SERVICE BULLETIN SB98.9

Machines/Models: SP37 & TL49

Serial Numbers:
SP37 1001-1345
TL49 1001-1135

PURPOSE: To increase the protection against abrasion and wear on the electrical harness between the Upper Control Box and Lower Control Box.

Figure 1

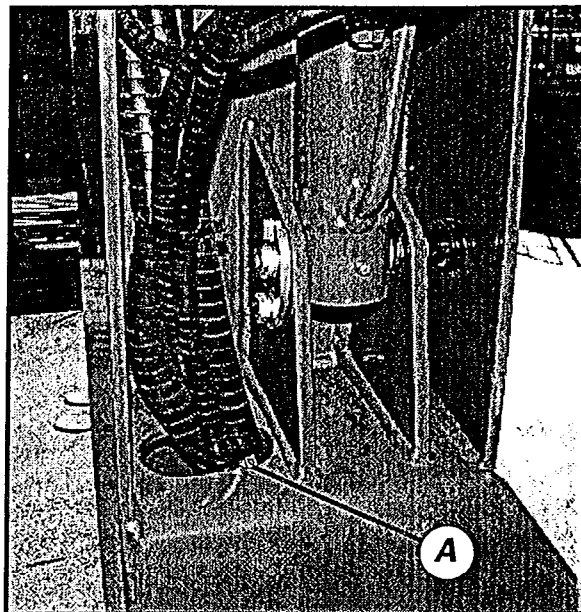
3. Clip the Harness Protection Coil around the harness above entry point **A**. See figure 1. Ensure that the full length of Coil is wrapped around the harness external to the Second Post.

4. Tie wrap the Harness Protection Coil loosely in three places.
5. Examine the harness and hose routing inside of the Second Post using the Access Panel.

Figure 2

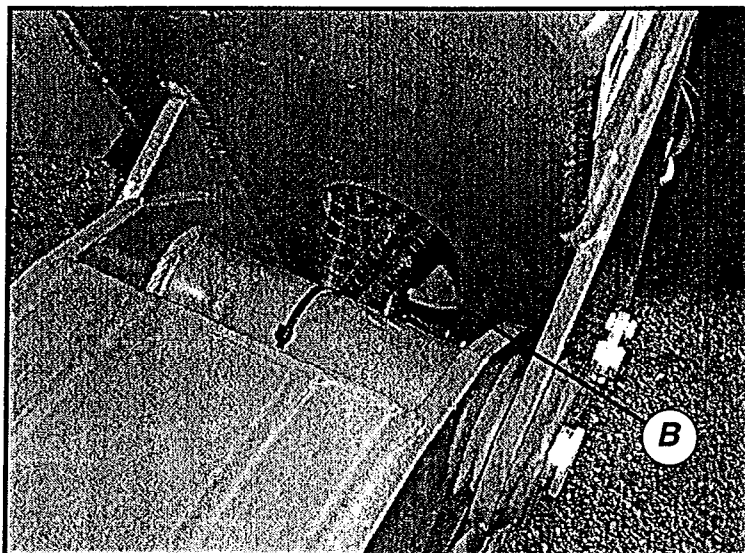
6. Slide the Harness Protection Coil down the Harness and thread it through the Second Post until it has come out of entry point **B**. See figure 2.
7. Tighten the Tie Wraps so that the Harness Protection Coil is secure. Tie Wrap the Coil loosely to the hoses within the Second Post. This will eliminate excessive movement.
